Draft Homebush Bay West Development Control Plan, Amendment 2 Submissions Report

December 2024

Department reference number: SF4/4829

Figure 2 | Existing layout of open space and tower forms³

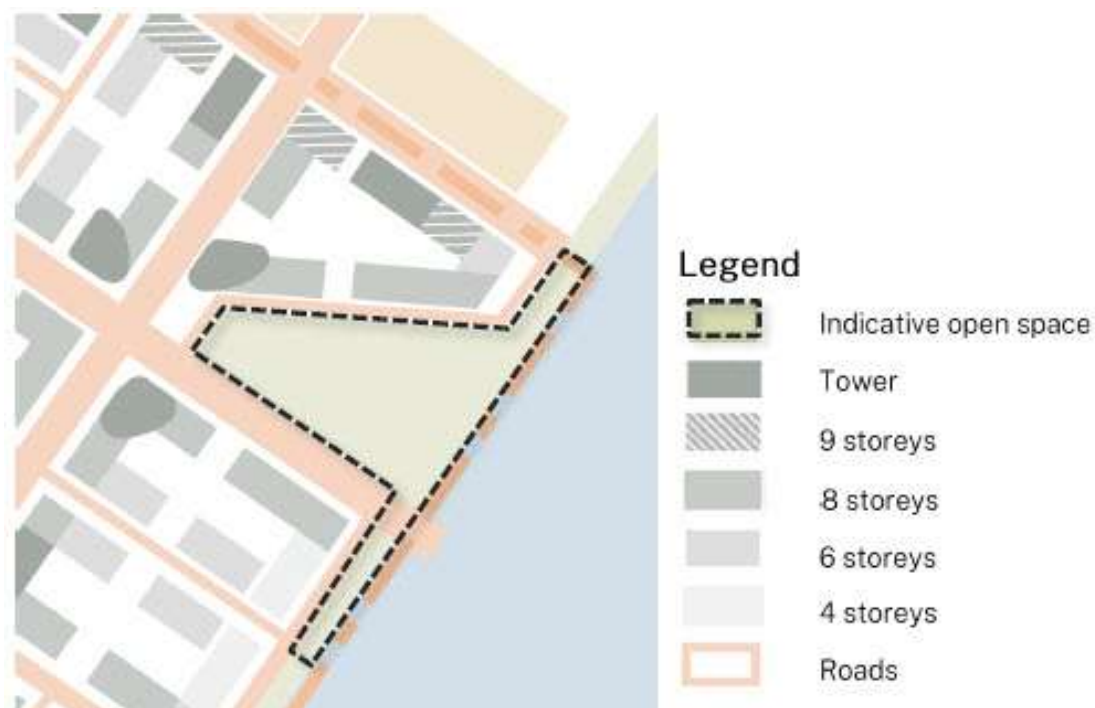
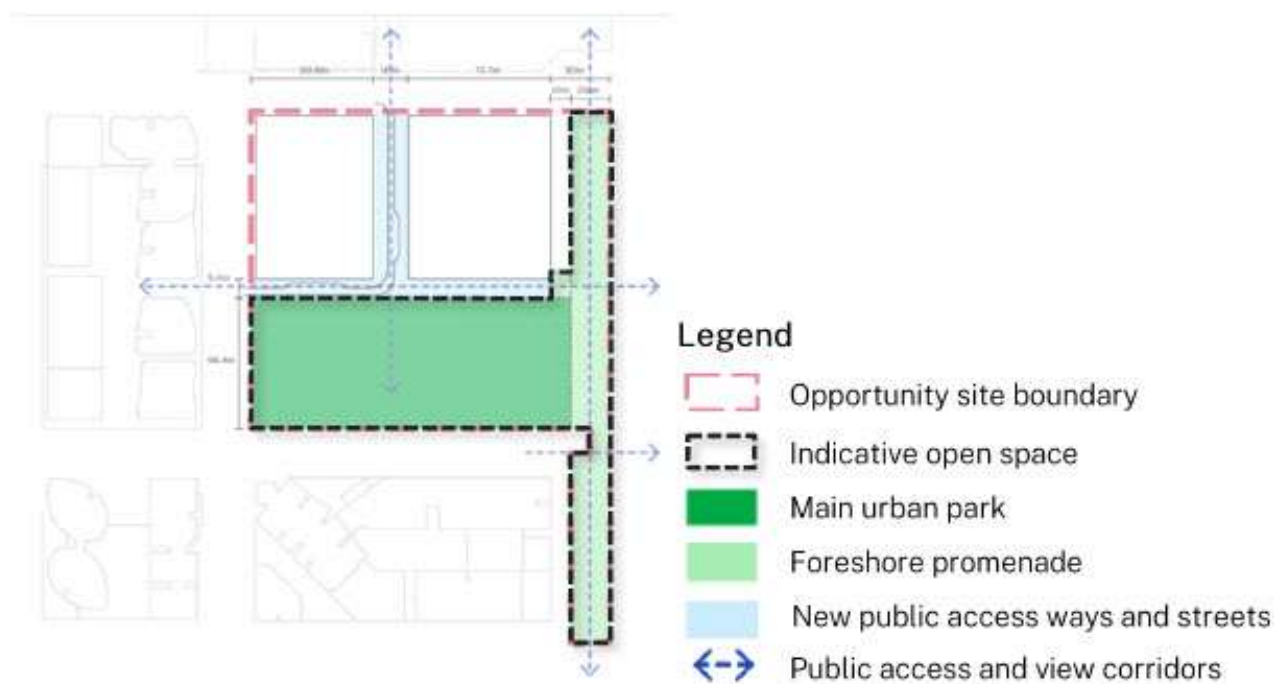
The draft Homebush Bay West Development Control Plan, Amendment 2 increases the area of the urban park within the site from 9,850 m² to 10,044 m² and reconfigures it from a wedge shape into a rectangular park. The reconfiguration should result in more usable space for a range of activities. Detailed planning of this open space will be undertaken as part of a future development application.

Figure 10 | Proposed locations of tower forms⁷

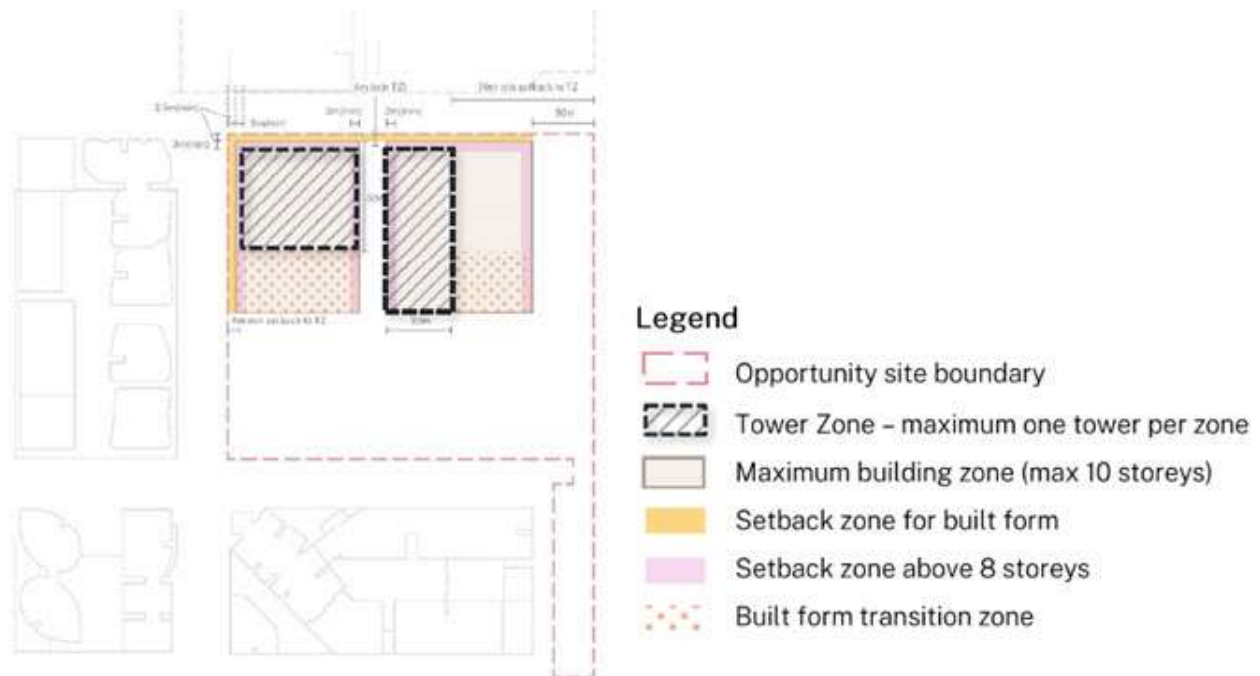
surrounding built form and local character. Concern was raised that the bases of the proposed 40-storey towers would create a poor interface with the surrounding development and public domain. Other submissions suggested a need to set buildings back from the streets and existing development to provide space for pedestrians.

The proposed amendment locates the future tower forms in the northern half of the site, as shown in Figure 10, rather than in separated locations on the site, as illustrated in Figure 2. This may reinforce the appearance of a wall of tower forms closer to Burroway Road.

The height of a building and the setback from the road help define the interface with the public domain and the adjoining development. Increasing the height of the base of the buildings on Block H from 8 to 10 storeys may result in an uneven interface with adjoining development and increase the perception of high density in the precinct. When viewed from the water and Rhodes, the additional bulk of the base of the towers may appear more dominant on the foreshore (refer to Figure 12).
